MANASQUAN PLANNING BOARD MEETING AGENDA

Re: Boro File No. MSPB-R2200 Variance – Nelson Block 122, Lot 25 321 Cedar Avenue R-2 Single-Family Residential Zone Borough of Manasquan, Monmouth County, NJ

Re: Boro File No. MSPB-R2210
Variance – Mark D. Hall Family Trust
Block 177, Lot 33.03
155 First Avenue
R-5 Single-Family Residential Zone
Borough of Manasquan, Monmouth County, NJ

Re: Boro File No. MSPB-R2230 Variance – Young/Estate of Emily Zirkler Block 168, Lot 16 139 First Avenue R-5 Single-Family Residential Zone Borough of Manasquan, Monmouth County, NJ

PROPOSED SITE DIAGRAM

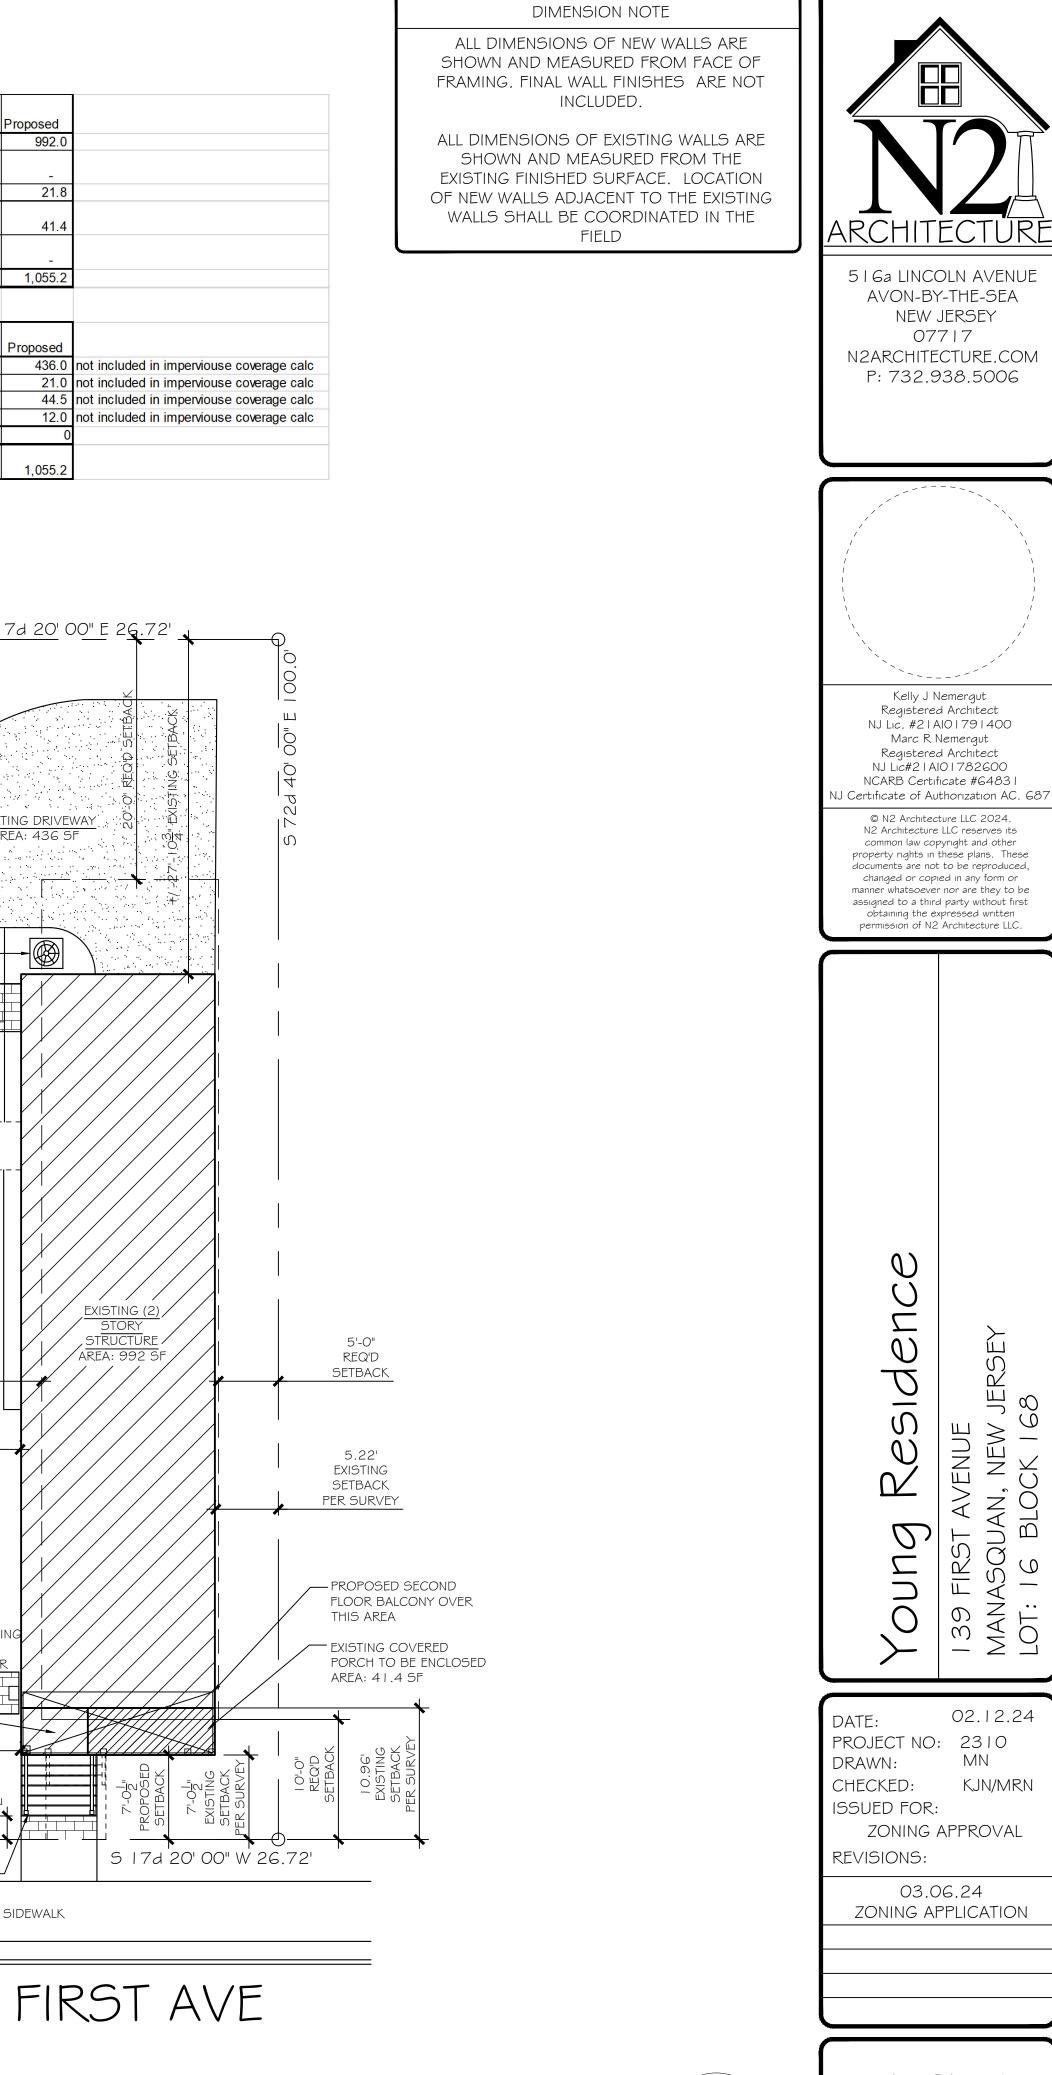
- c. A maximum building coverage of 35% is permitted, whereas a coverage of 39.5% exists.
- d. A minimum mechanical side yard setback (corner) of 7 feet is required to the proposed air conditioning unit, whereas approximately 6 feet is proposed.

- 6. If the property has existing stormwater recharge systems for the downspouts, they must be reconnected after the dwelling has been raised.
- 7. The existing air conditioning unit is to be elevated on the rear wall of the dwelling. A proposed elevation has not been provided but it will need to be installed above the BFE.
